City of Bowie, Maryland
Allen Pond Park Stage and Stage Canopy Renovation
Invitation for Bids (IFB)

Addendum #1

Date: October 2, 2025

E001

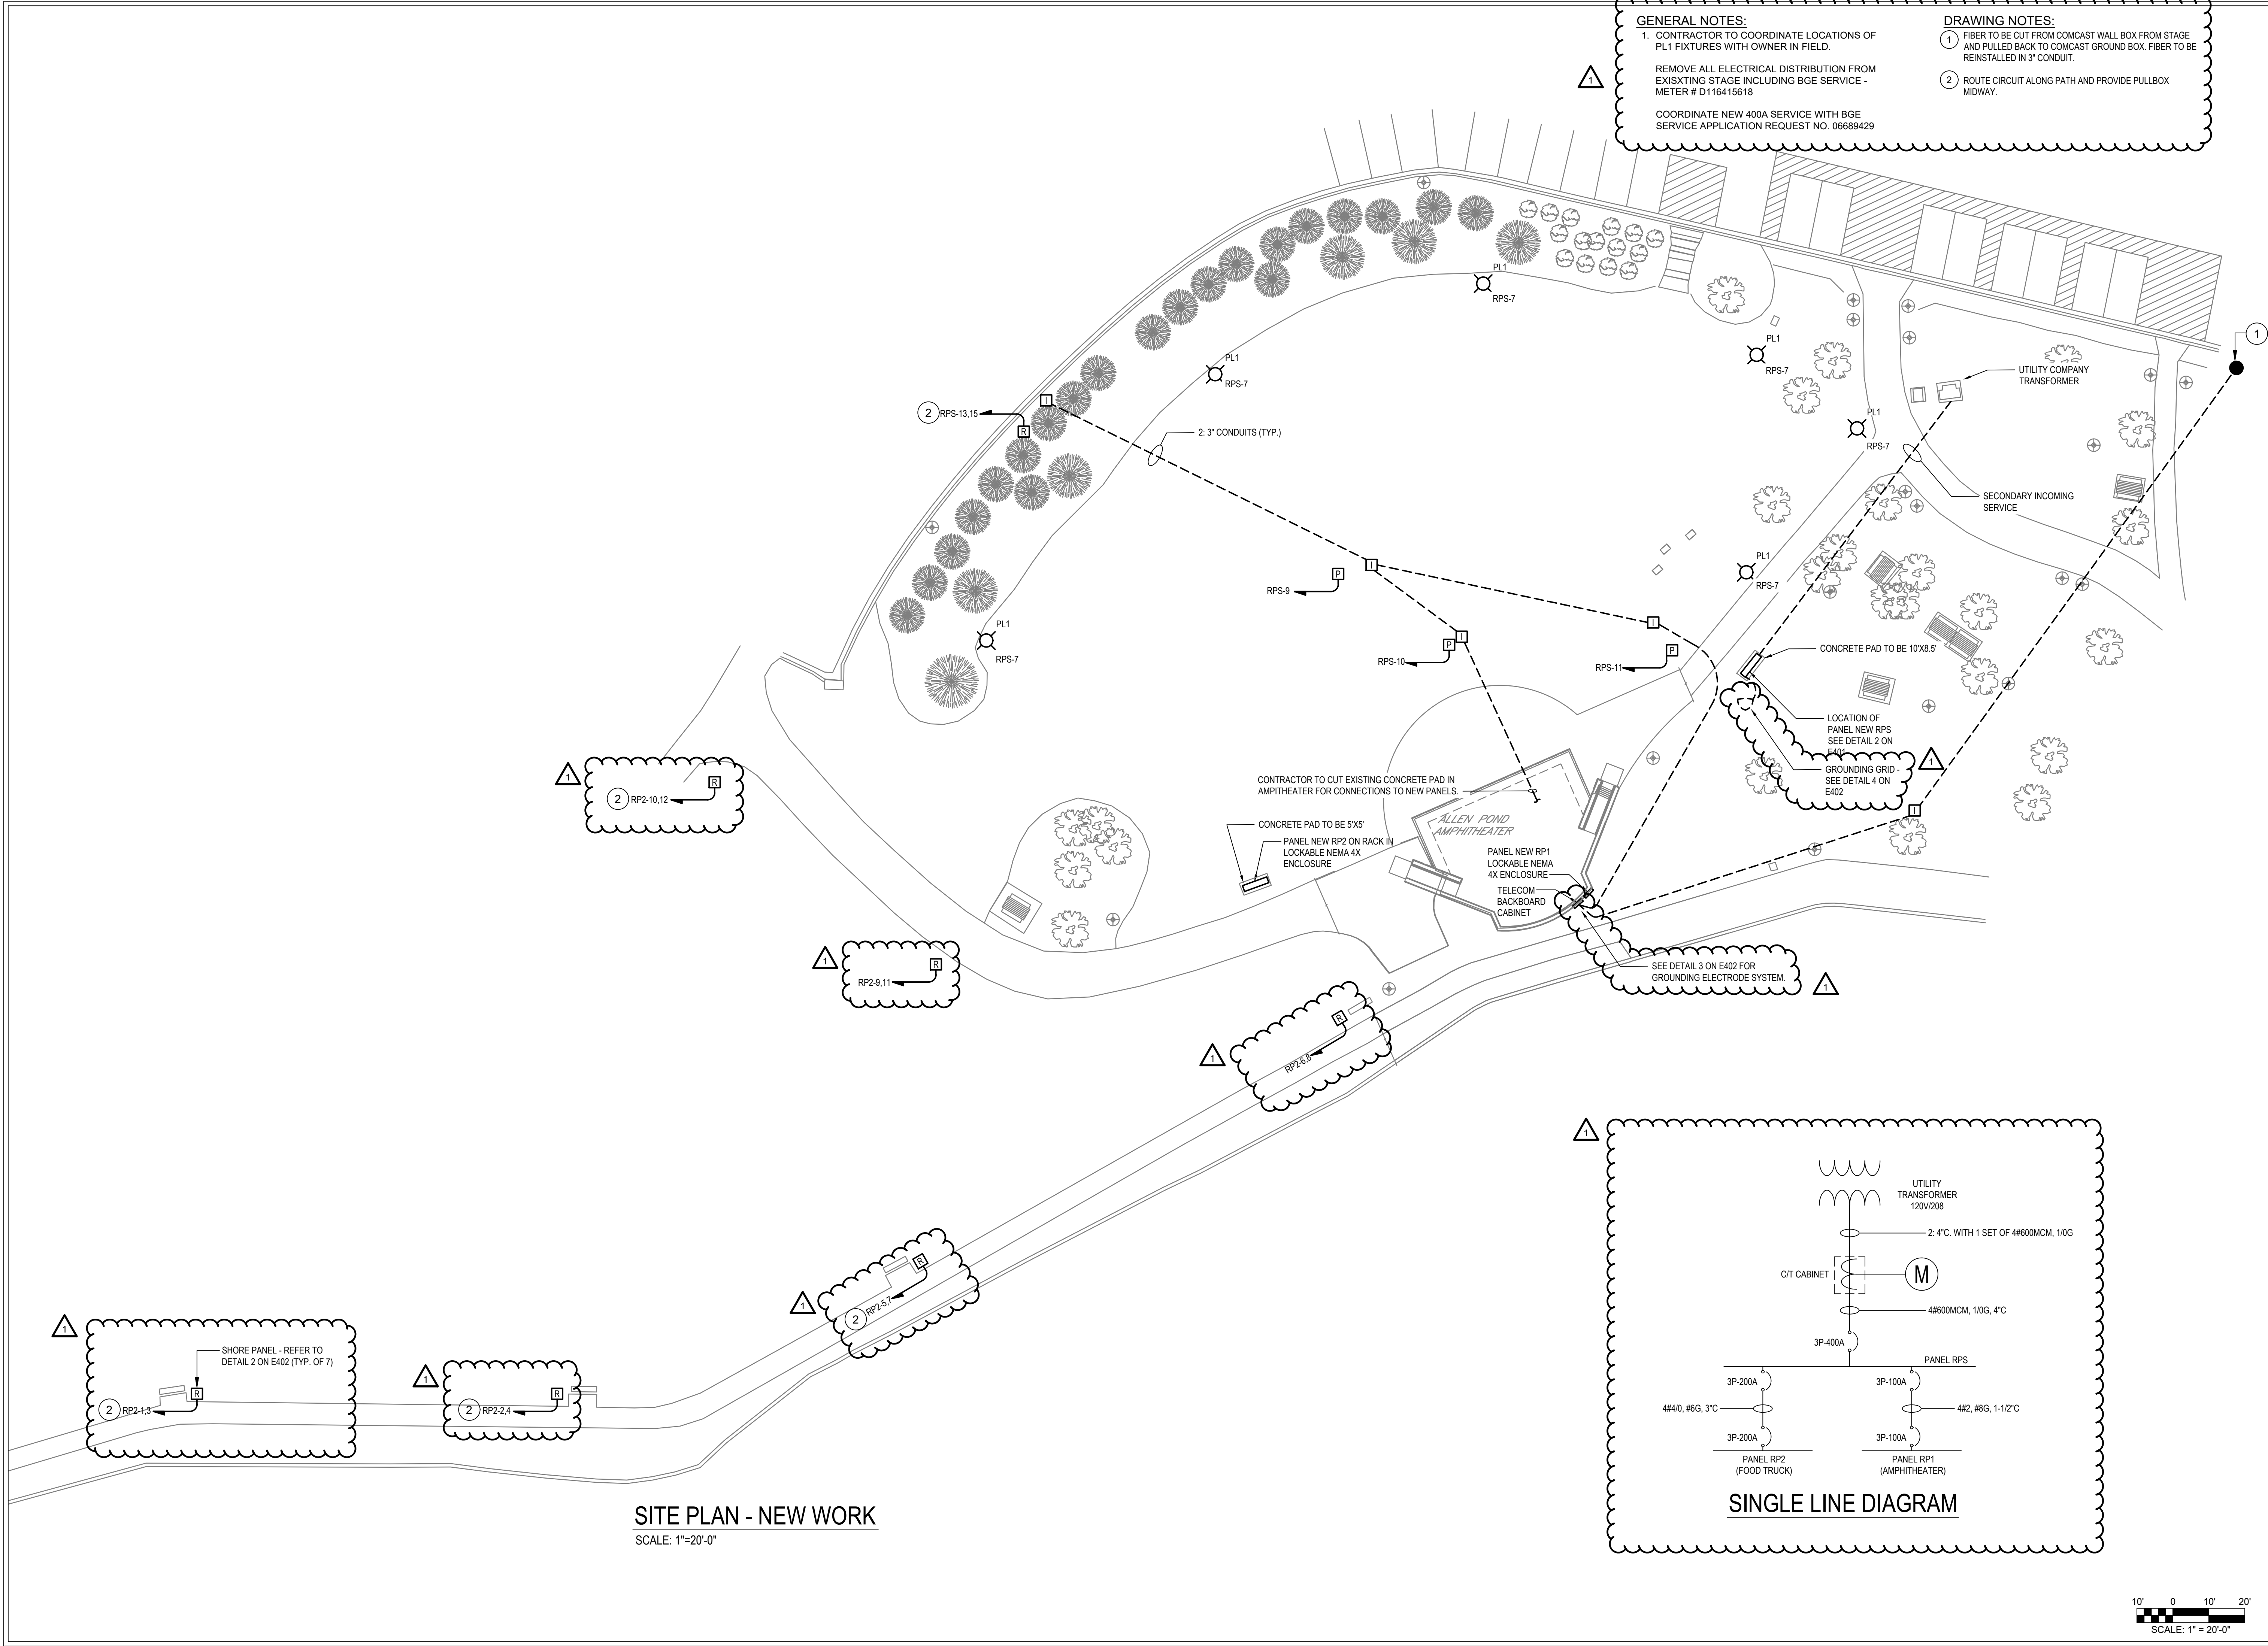
E001	Shore panel added to symbols legend
-------------	-------------------------------------

ES101

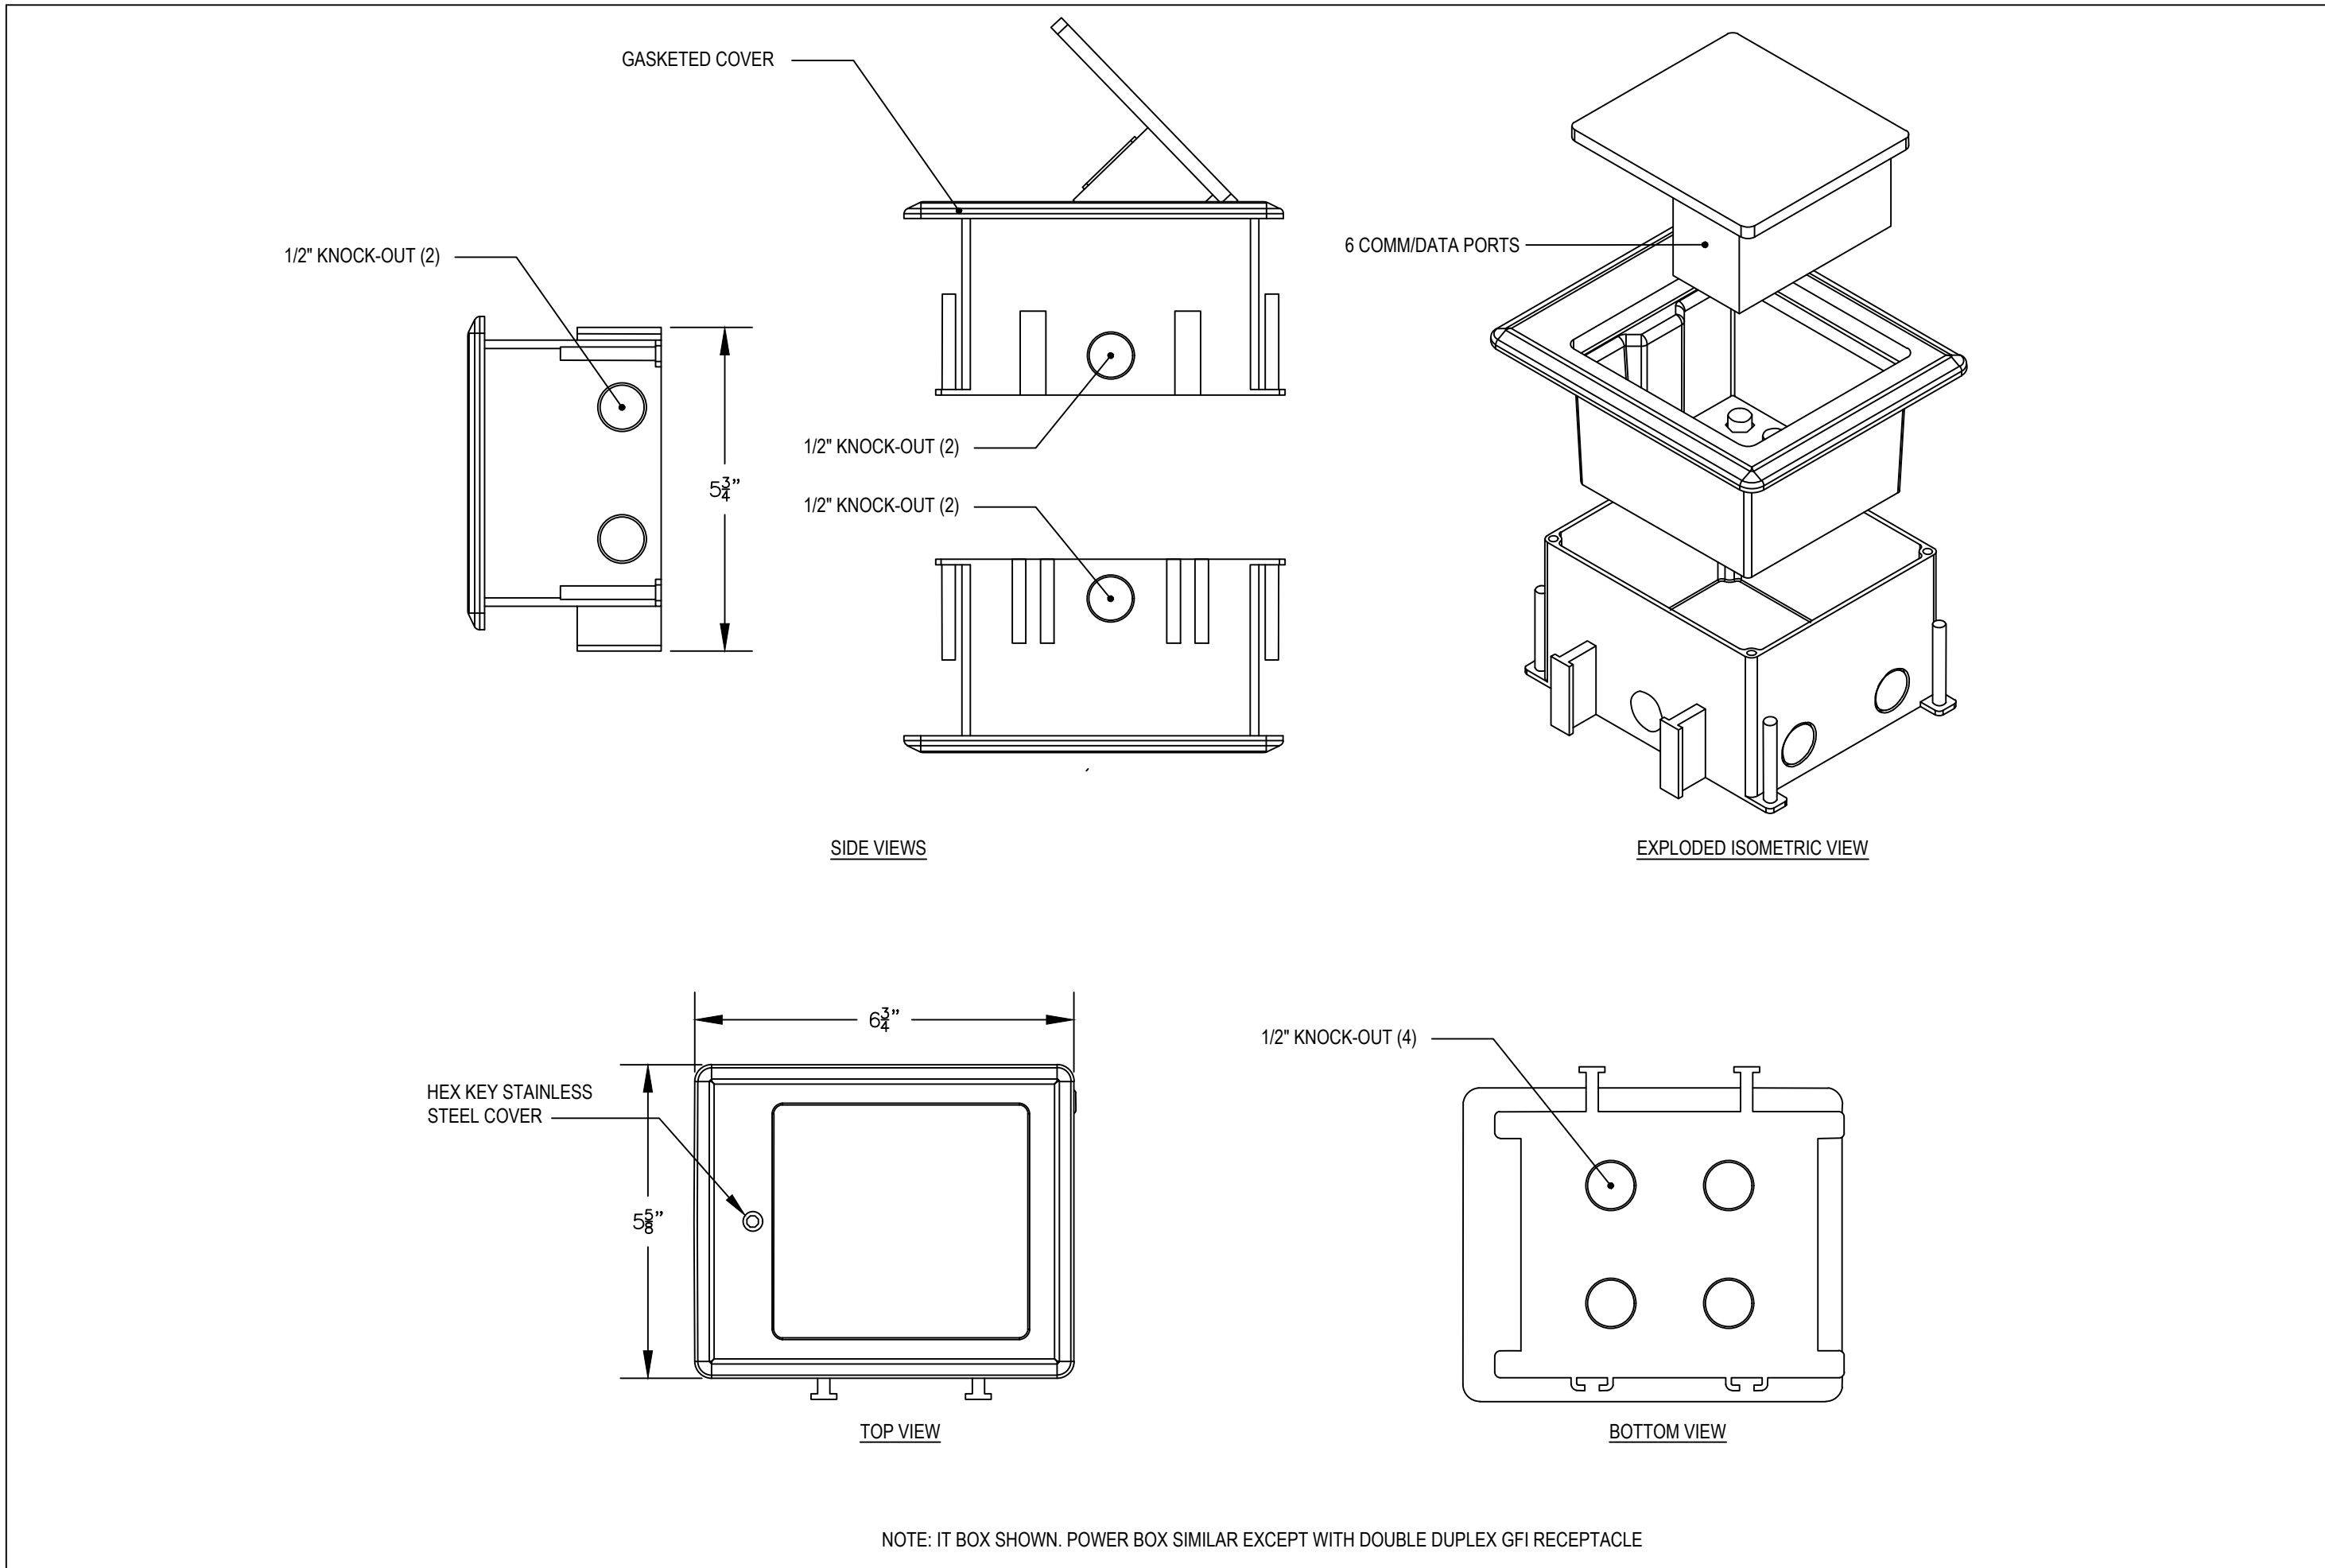
ES101	General Notes and Drawing Notes added. Reference to Grounding Details and Shore Panels added. Single Line Diagram modified to add wire sizes.
--------------	---

E401

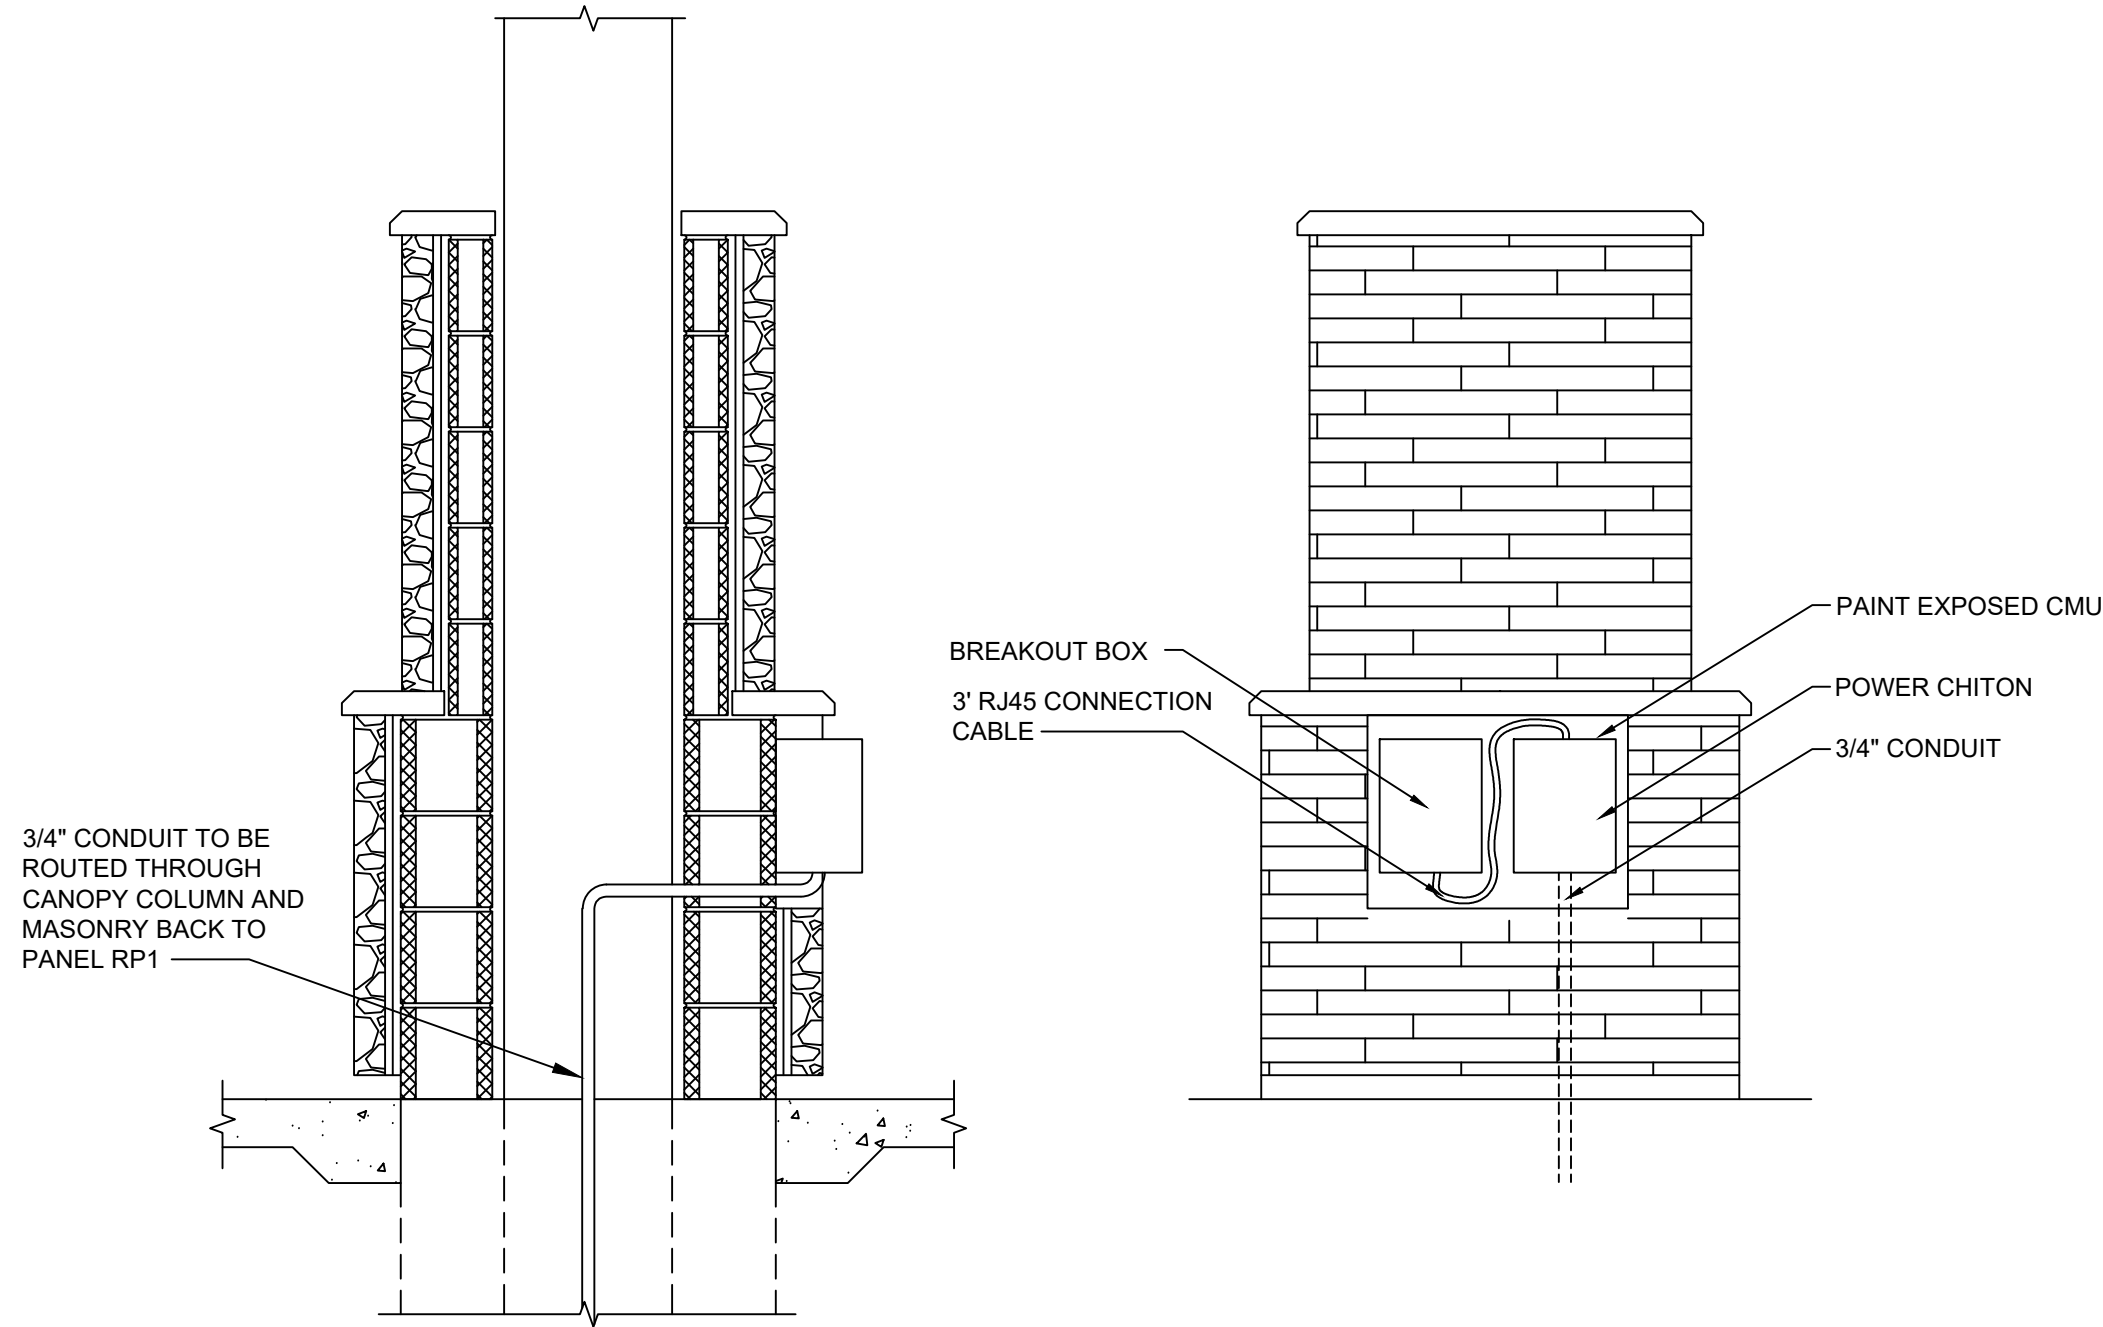
- E401** Modified Detail 2/E401 to remove “IT Cabinet.”
- E402** Added Detail 2/E402, Shore Panel Enclosure; Detail 3/E402, Grounding Electrode System; and 4/E402, Ground Grid.
- E601** Removed Voltage Drop Schedule and modified Panel Schedules.
